**Touquoy Gold Project
Modifications – Environmental
Assessment Registration
Document Addendum No. 2**

December 21, 2022

Disposition of information requests from the May 12, 2022 letter from the Minister of Environment and Climate Change

The following table provides a disposition of the comments included in, “Table 1 Detailed Review Comments and Recommendations Regarding Appendix D.1 and D.2” from the Wood (2022) Water Modelling Third-party Review of the Touquoy Gold Project Site Modifications -Environmental Assessment Registration. Existing documentation that is referenced throughout this table includes:

Figure 6-3 **Compilation Bedrock Hydraulic Conductivity (Historical and 2021 Investigation)**

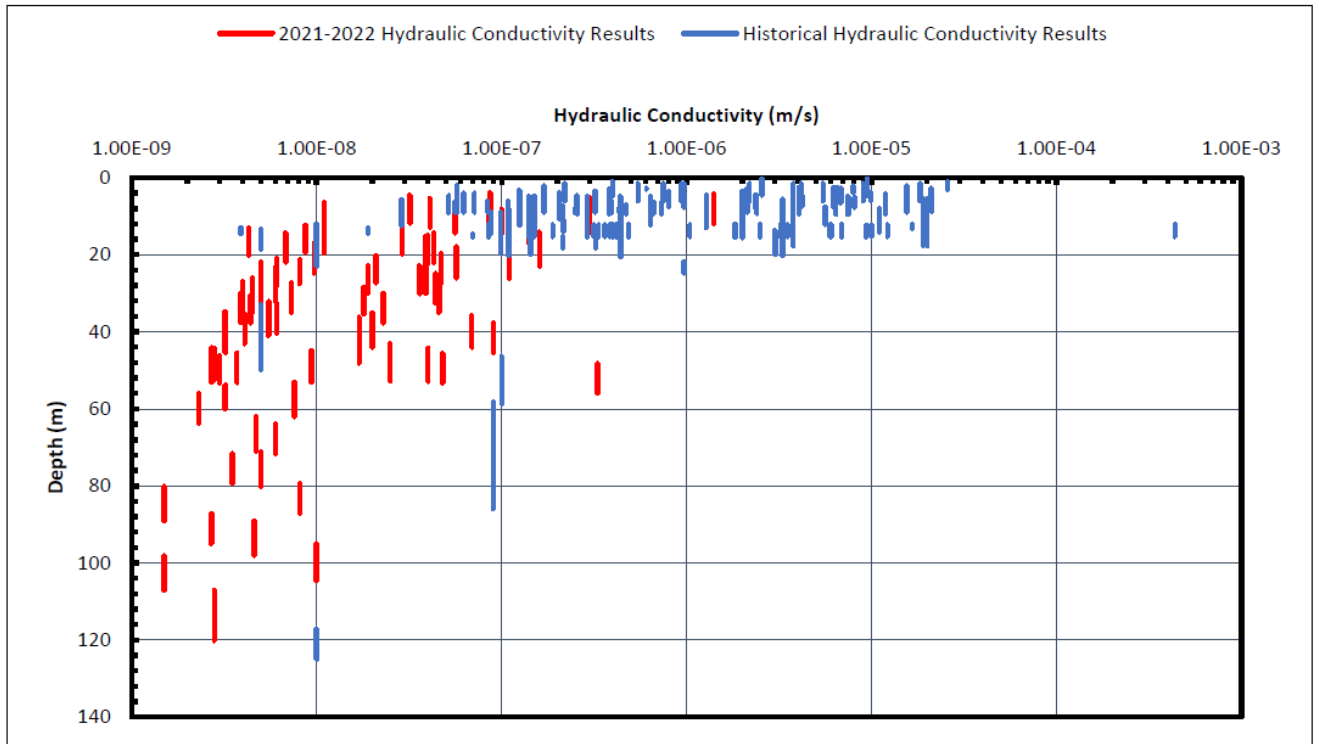
5	<p>Section 4.2, - Distribution of Hydrogeological Parameters pg 4.4 (25):</p> <p>It would be beneficial to include Figures showing the locations and inferred values from hydraulic testing. A histogram of hydraulic test results would also be useful in demonstrating that using the geometric mean value for input hydraulic conductivity is appropriate.</p>	<p>Figure 6-3 in the Factual Data Report (Appendix B.1 of the March Additional Information Addendum) provides the requested histogram showing the distribution of hydraulic conductivity with depth. This figure has been included as Attachment B. The additional packer testing completed in late 2021 was within ranges of historical hydraulic conductivity testing. Table 2.4 in the Updated Groundwater Modeling Report, provided as Appendix B.3 of the March Additional Information Addendum, provides the hydraulic conductivity values assigned to each model layer following calibration and sensitivity analysis.</p>

Histogram showing the variation of hydraulic conductivity with depth around the Open Pit, Touquoy Mine Site provided as part of the response to Lines 4 and 17 of Table 1

Residuals Distribution Map in response to Line 14 of Table
A and Line 5 of Table 2

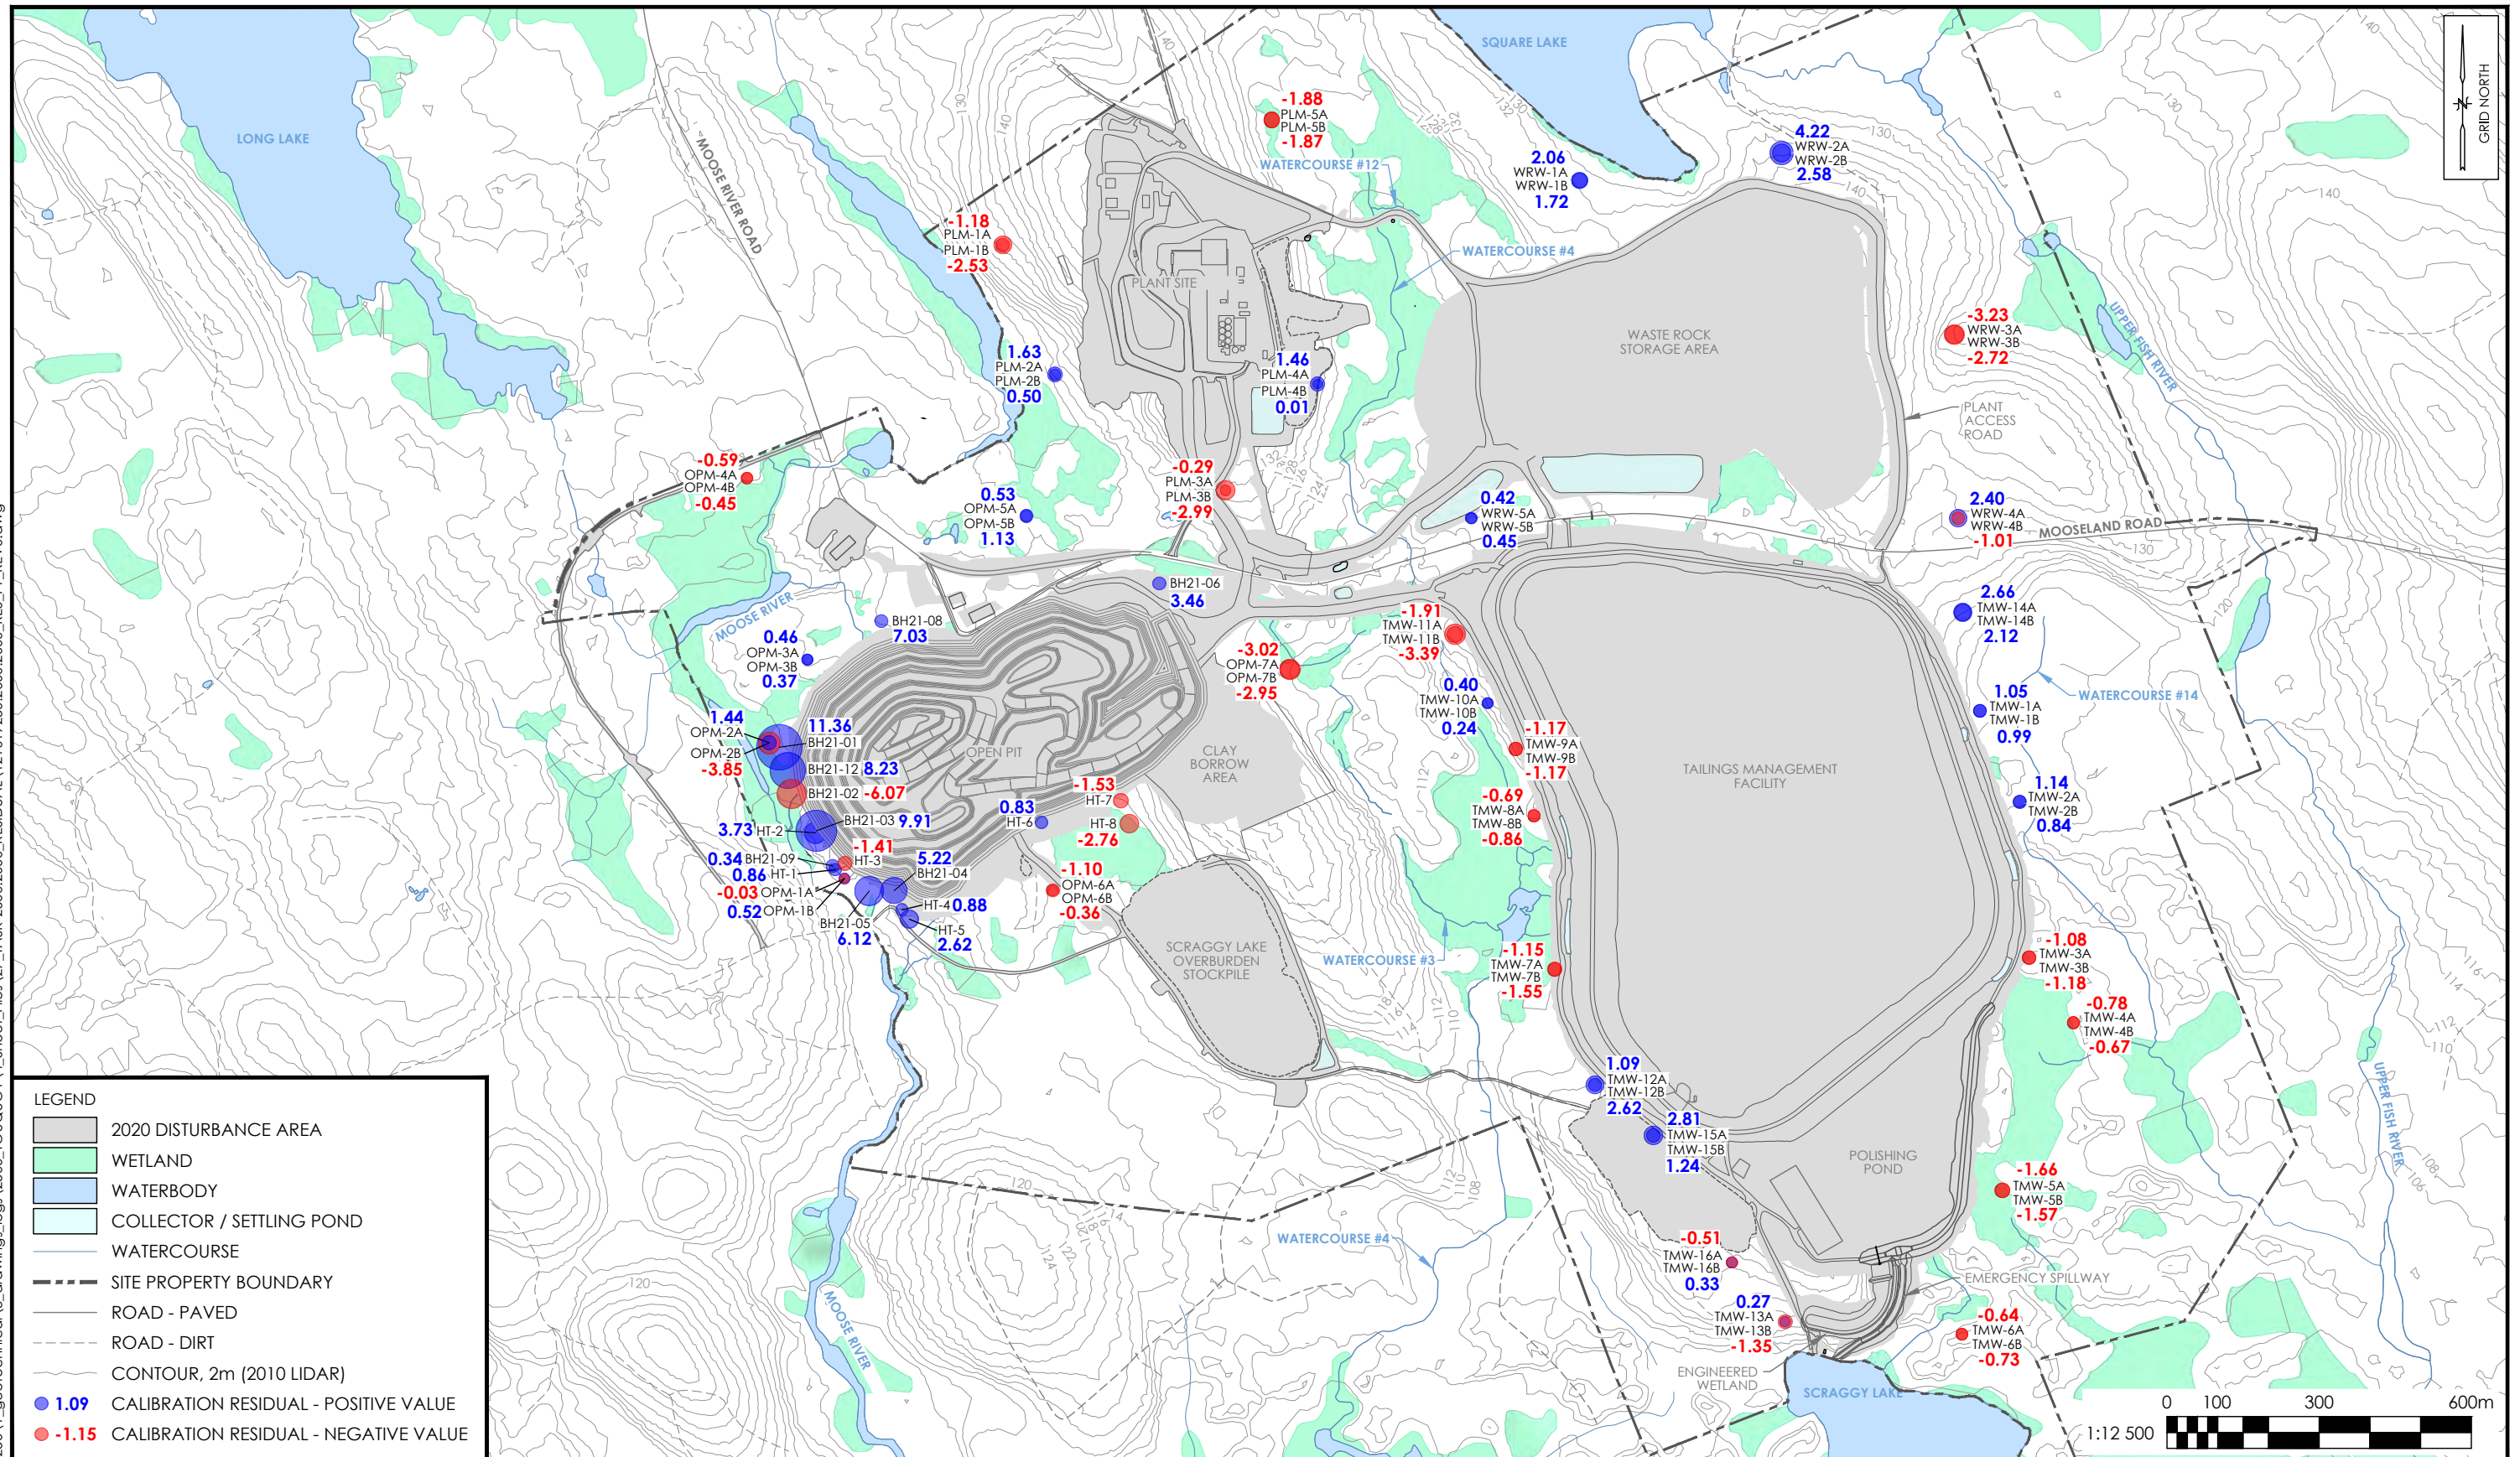
13	<p>Section 4.4.2, - Calibration to Water Levels pg 4.8 (29):</p> <p>Figure 4.5 – wells 6749 and 6719 are shown on figure but not included in the data tables, if they have not been used in model calibration they should be removed from the figure.</p>	<p>This is an opinion on data presentation and is not pertinent to the performance of the model. For clarification, neither of the water wells were used in the model calibration.</p>
14	<p>Section 4.4.2, - Calibration to Water Levels pg 4.14-4.15 (35-36):</p> <p>Although the overall model calibration statistics appear reasonable, a residual distribution map should be included to see, even if only qualitatively, if there are any areas where there could be bias in the model predictions. From Figure 4.6 it looks as if model calibration may not be as good in those areas with observed groundwater elevations above about 125m. From Figure 3.7-3.8 of Stantec (2021) it looks as if areas of >125m gw elevation are located around the WRSA and Plant site which are areas of primary importance in Appendix D2 – Waste Rock Storage Area Groundwater Modelling Update.</p>	<p>A residual distribution map has been included as Attachment D. As shown on the figure, residuals do not show a bias high or low around any particular area within the model domain. A balance of positive and negative residuals are observed around all project components</p>

Updated particle tracks for the Waste Rock Storage Area (WRSA) under average annual conditions.

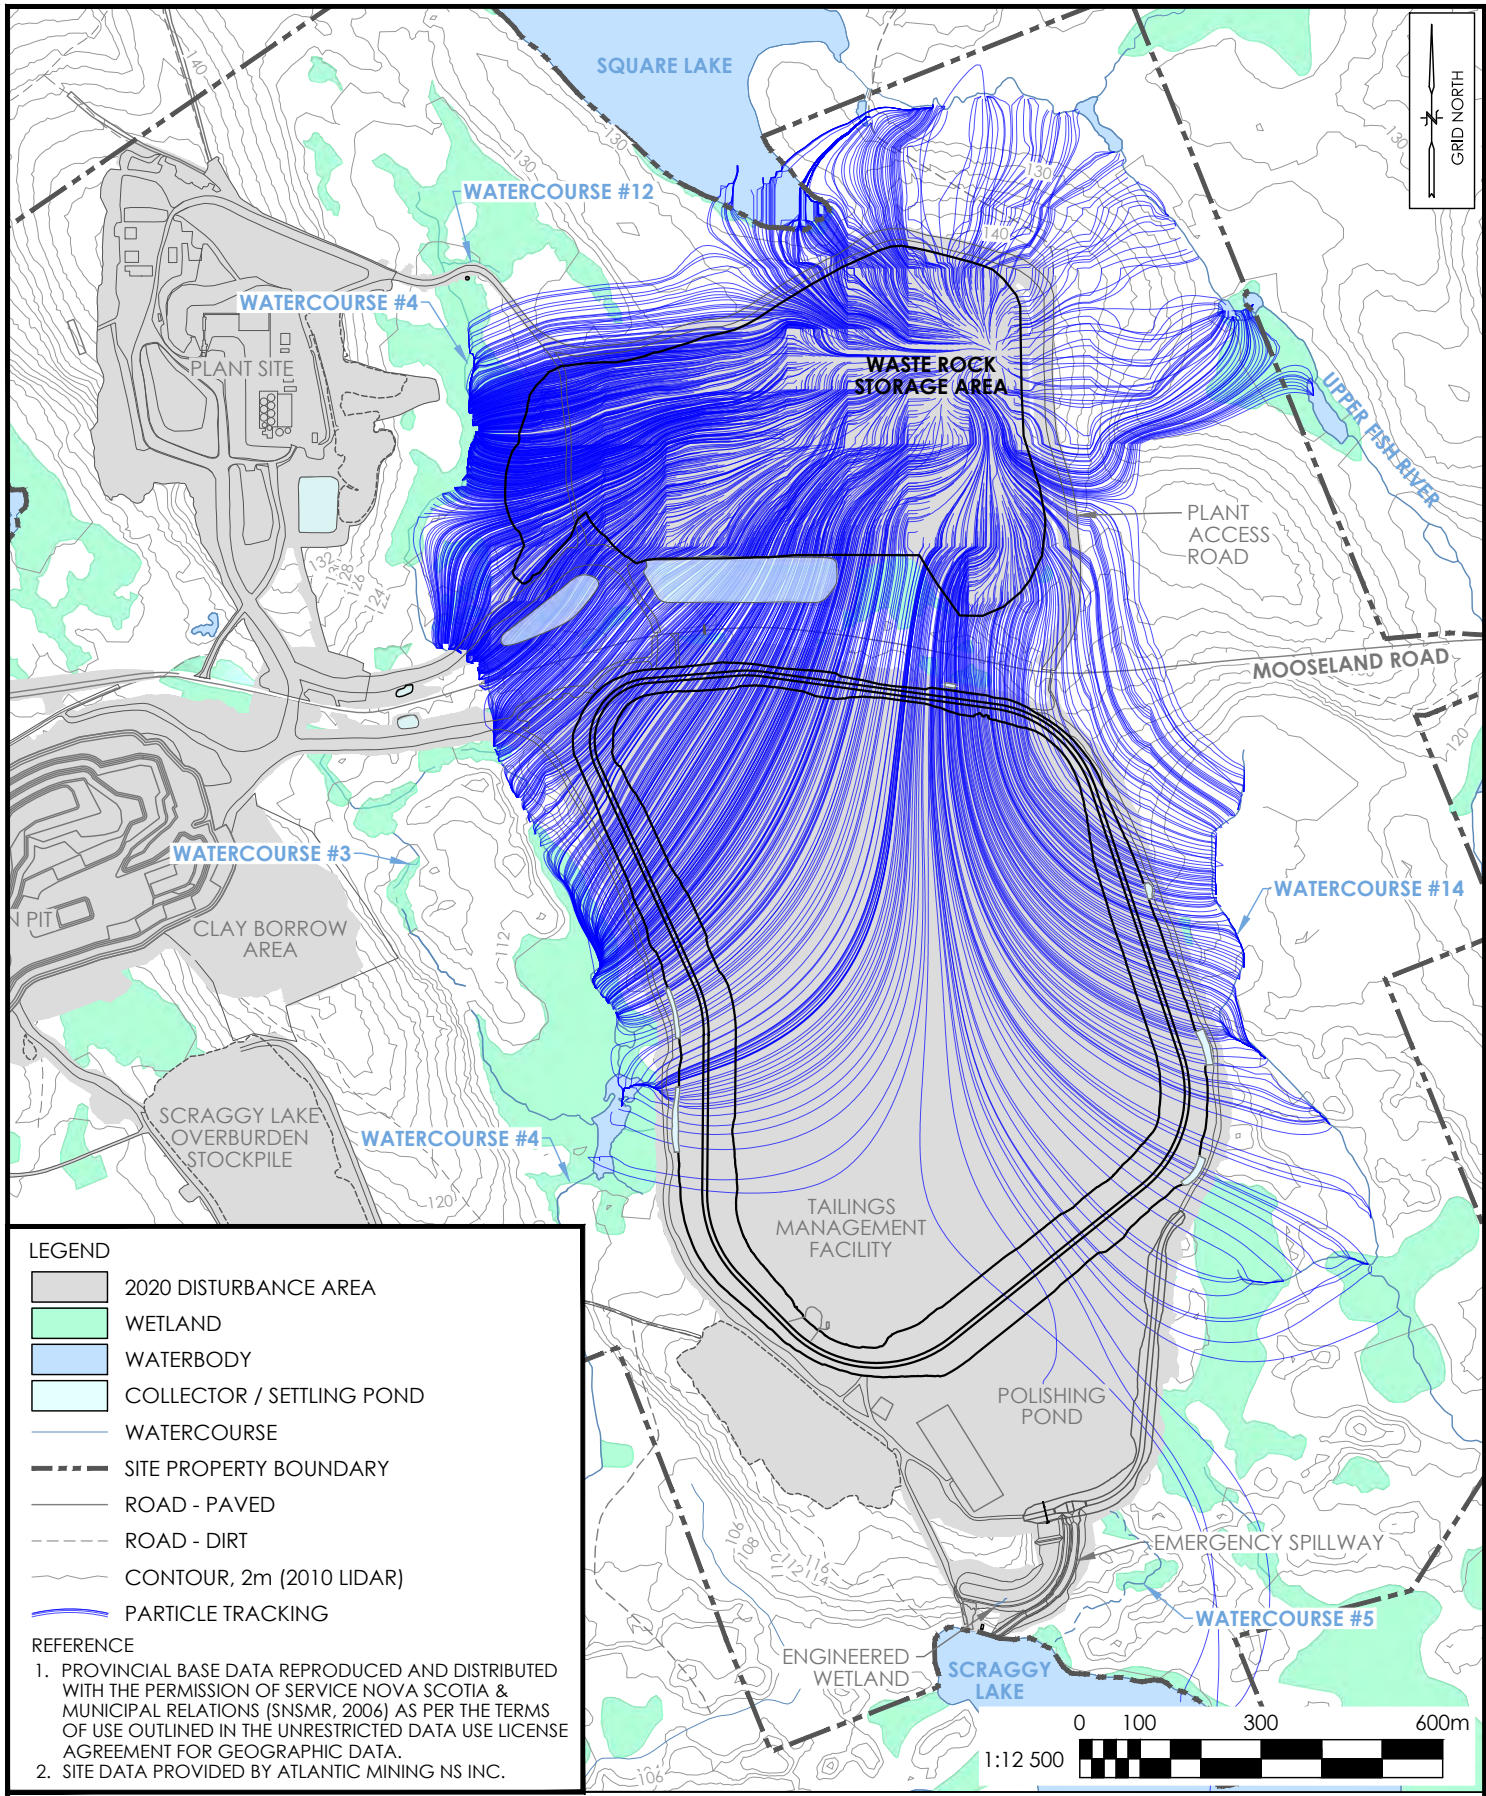
ID	Summary of Comments and Recommendations with Respect to the Groundwater Model	Atlantic Mining Response
4	<p>Methodology pg 2</p> <p>Should mention/reference what software code was used to calculate particle tracks.</p>	<p>MODPATH, the particle tracking companion software to MODFLOW was used to calculate the particle tracks (Pollock, 2012).</p> <p>Pollock, D.W., 2012. User Guide for MODPATH Version 6 – A Particle-Tracking Model for MODFLOW. U.S. Geological Survey Techniques and Methods 6-A41. Reston Virginia.</p>
5	<p>Methodology pg 3</p> <p>A plot of model computed and inferred hydraulic head values over the WRSA/TMF footprints and nearby surface water receptors should be included along discussion of the model match to the observed heads.</p>	<p>A figure showing the calibration residuals has been included as Attachment D. There is reasonable agreement between the computer and measured hydraulic head values around the WRSA and TMF.</p>
